Proposal Request

PROJECT: *(name and address)*
AWSOM
Bentonville, Arkansas

PROPOSAL REQUEST 039

MSE Walls, Curbs, and Grading

4 Exhaust Well Edge
1"=1'-0"

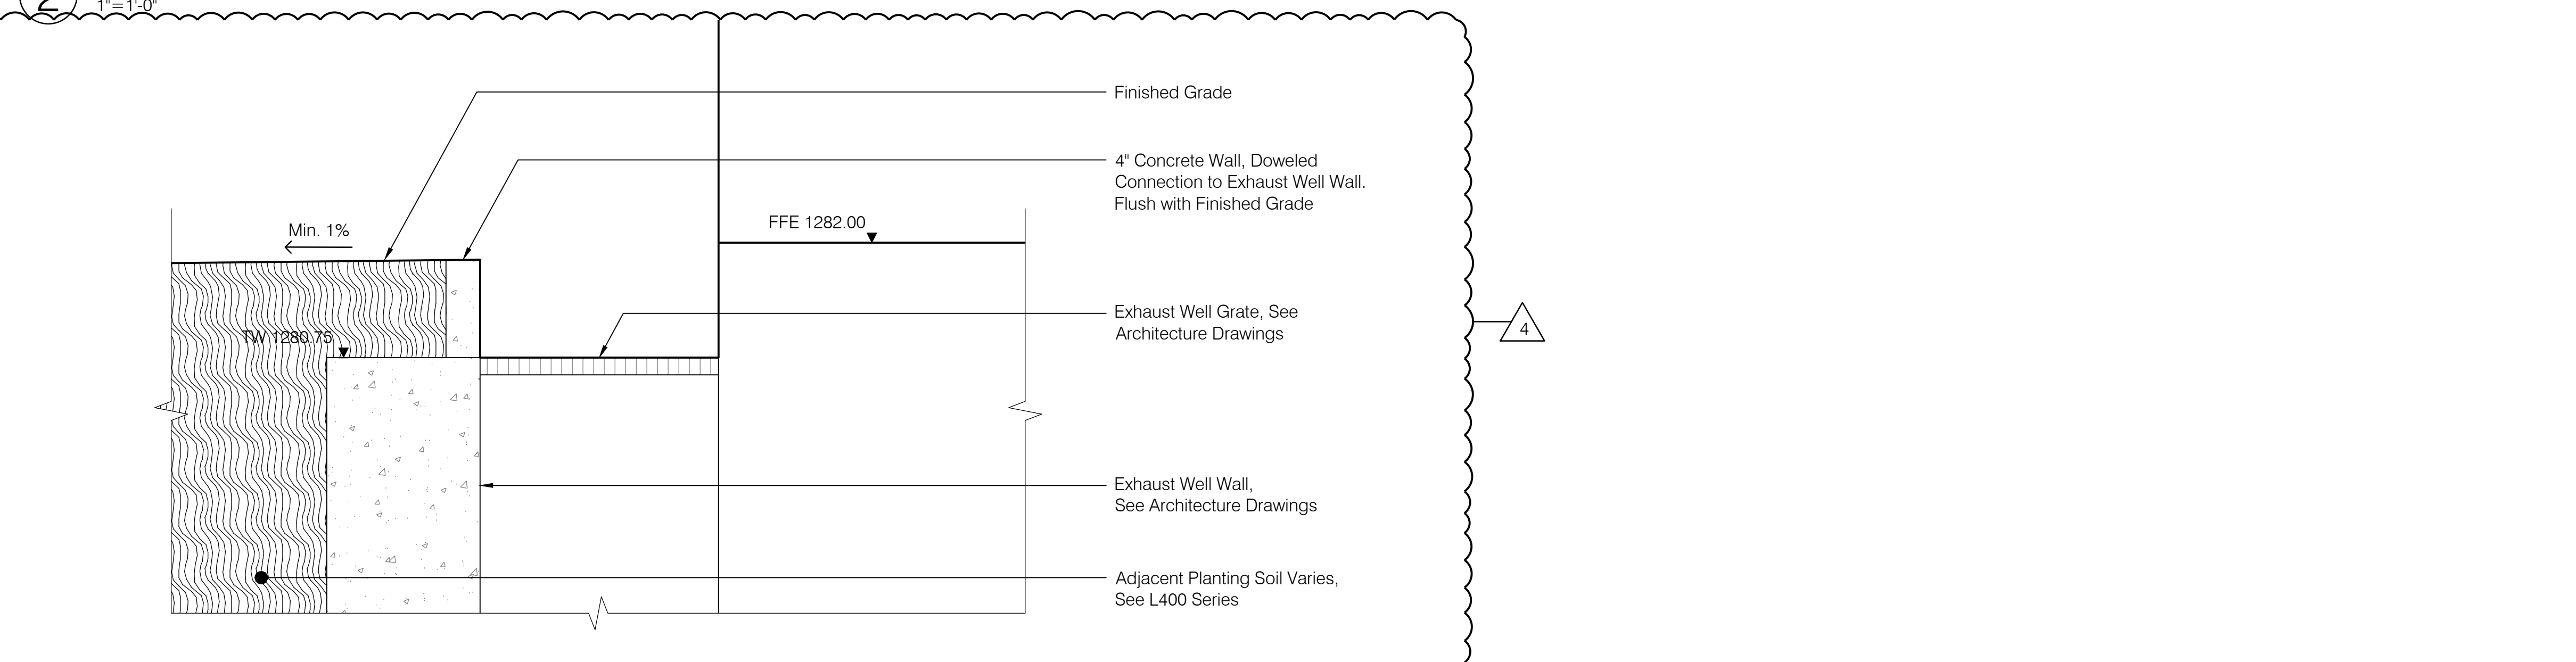
- Exhaust Wall Edge Detail Added (4/L905)

1 LO - 1/8" DIMENSION PLAN - AREA B
1/8" = 1'-0"

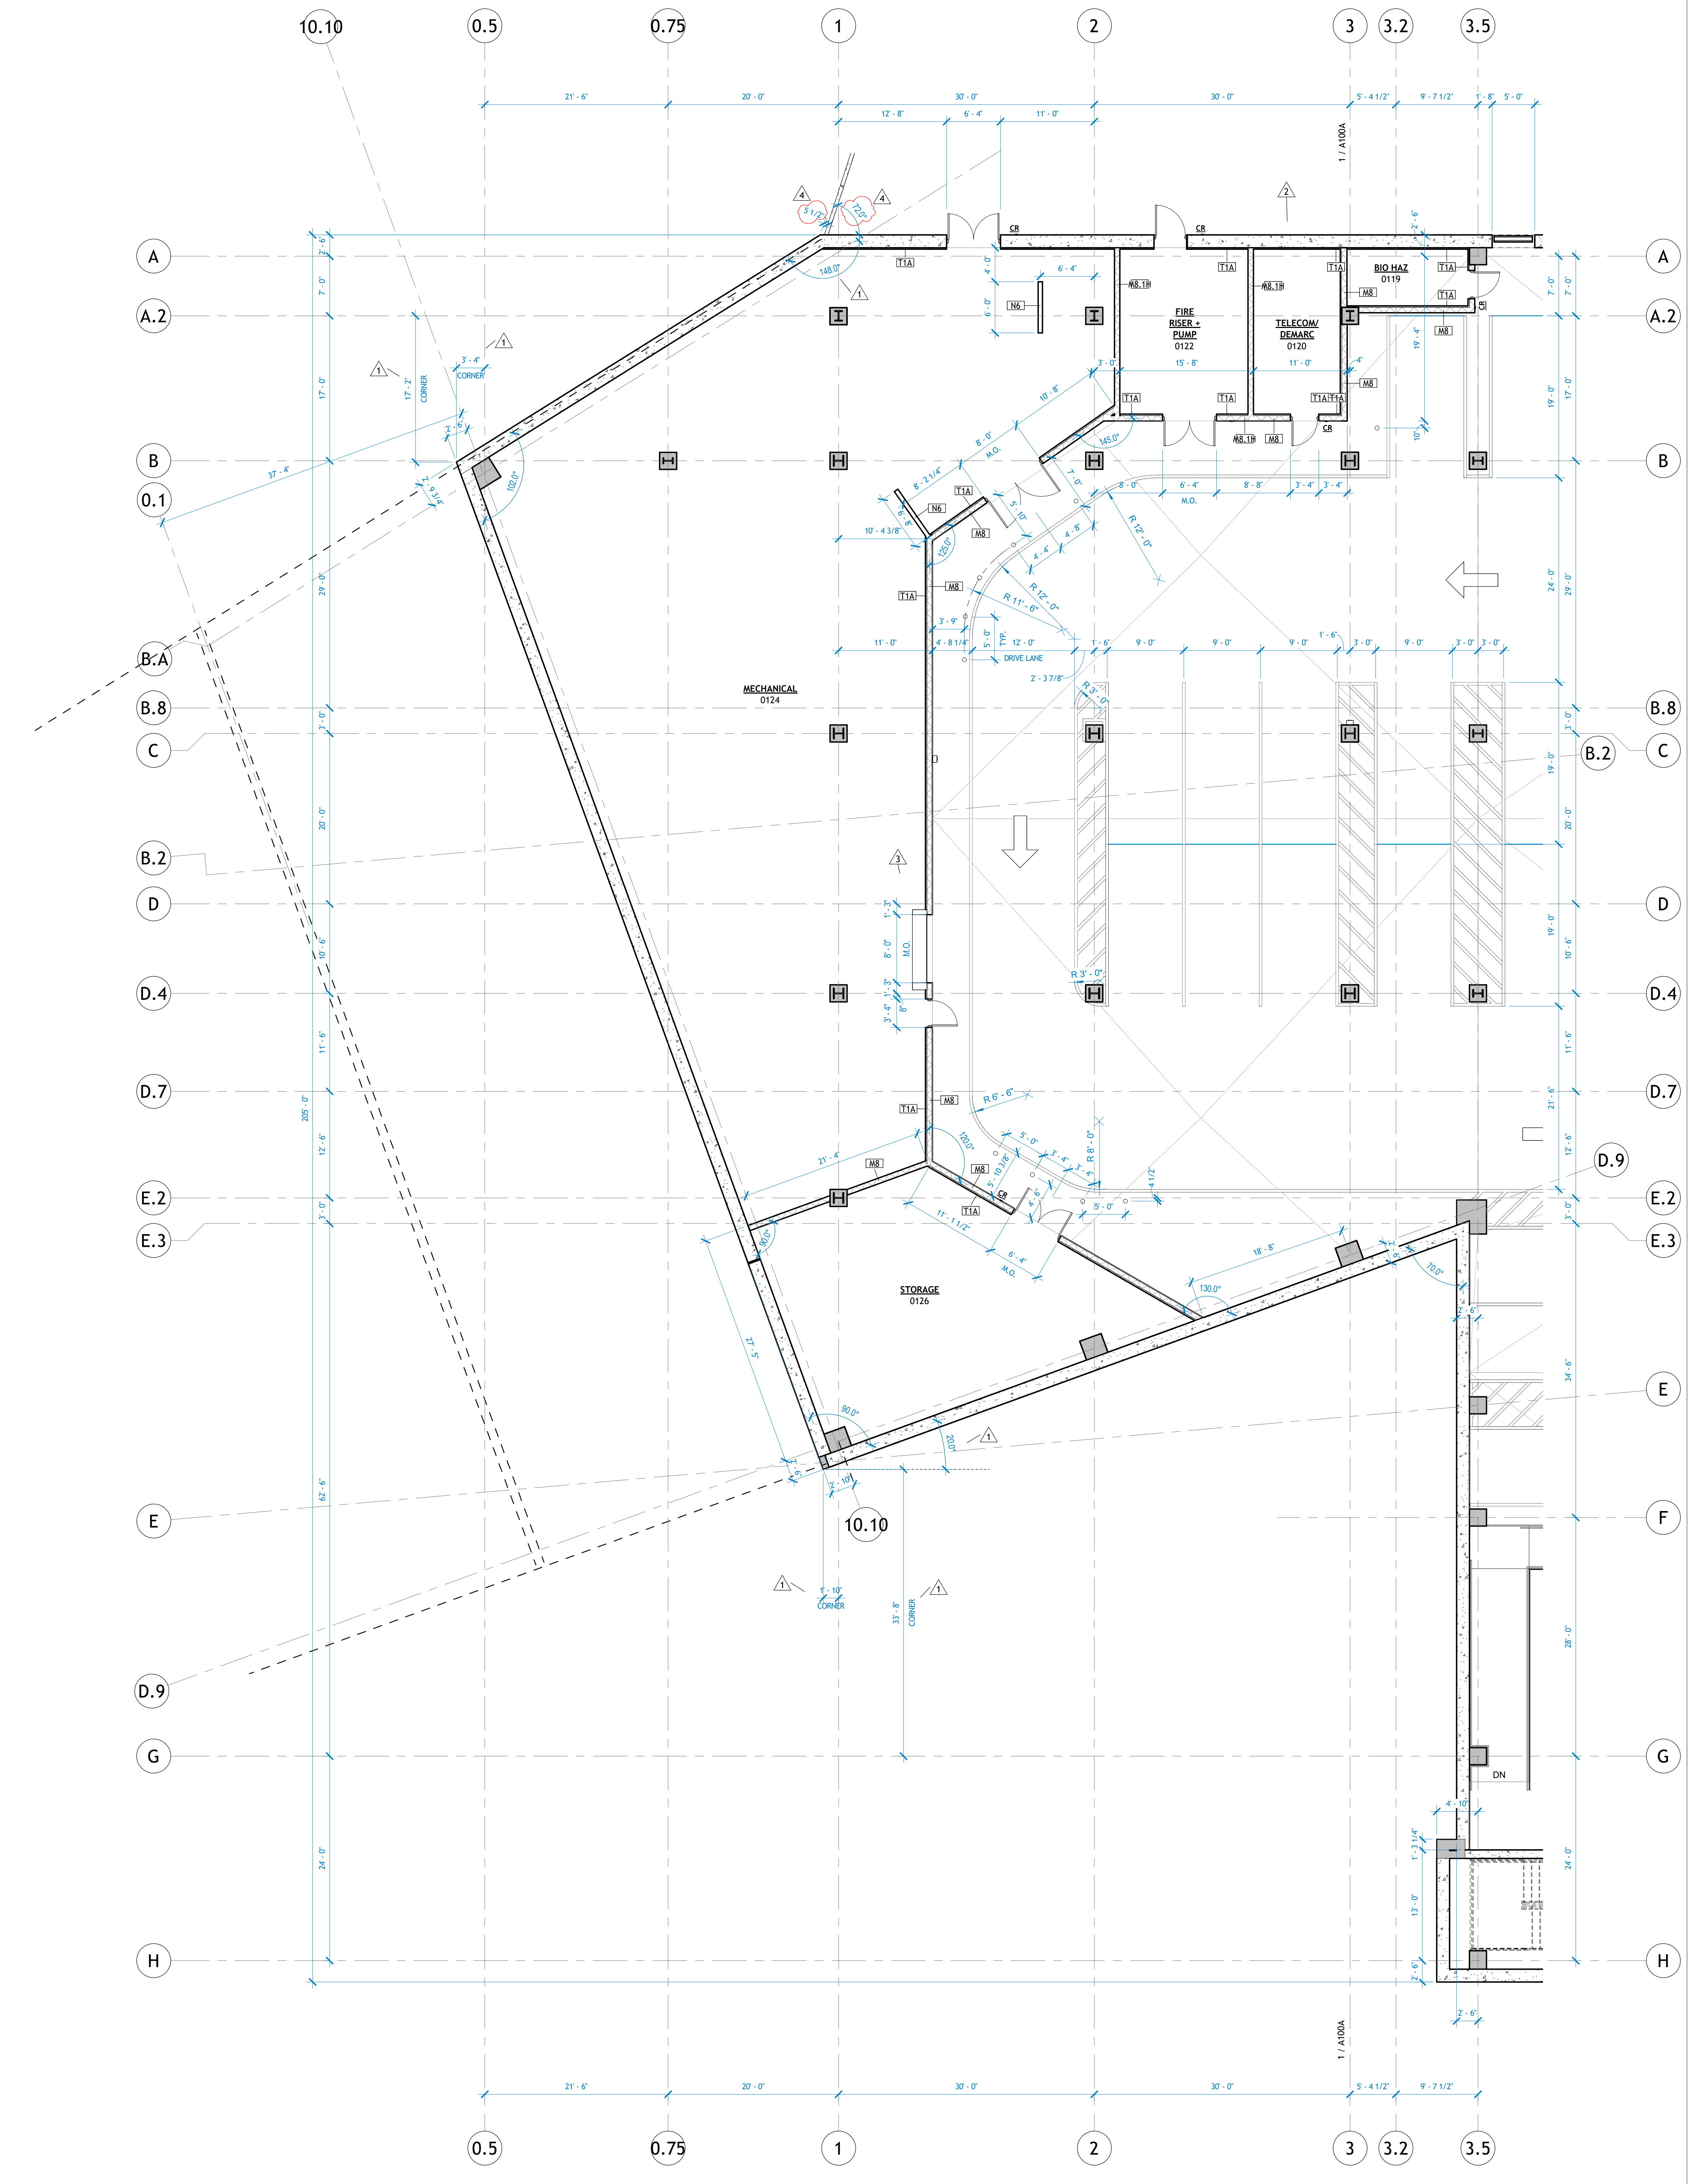
- a) Refer to Revised Sheet **A100AD**, with original issue date 02.24.2023 and revised date 04.04.2024.
 - Dimensions on MSE wall revised.
- b) Refer to Revised Sheet **A100BD**, with original issue date 02.24.2023 and revised date 04.04.2024.
 - Dimensions on MSE wall added.
 - Note on landscaping curb added.
- c) Refer to Revised Sheet **A101A**, with original issue date 02.24.2023 and revised date 04.04.2024.
 - Notes on MSE walls omitted.
- d) Refer to Revised Sheet **A101B**, with original issue date 02.24.2023 and revised date 04.04.2024.
 - Notes on MSE walls omitted.
- e) Refer to New Sheet **A607**, with original issue date 04.04.2024.
 - New MSE wall layout added.
 - New guardrail details added.
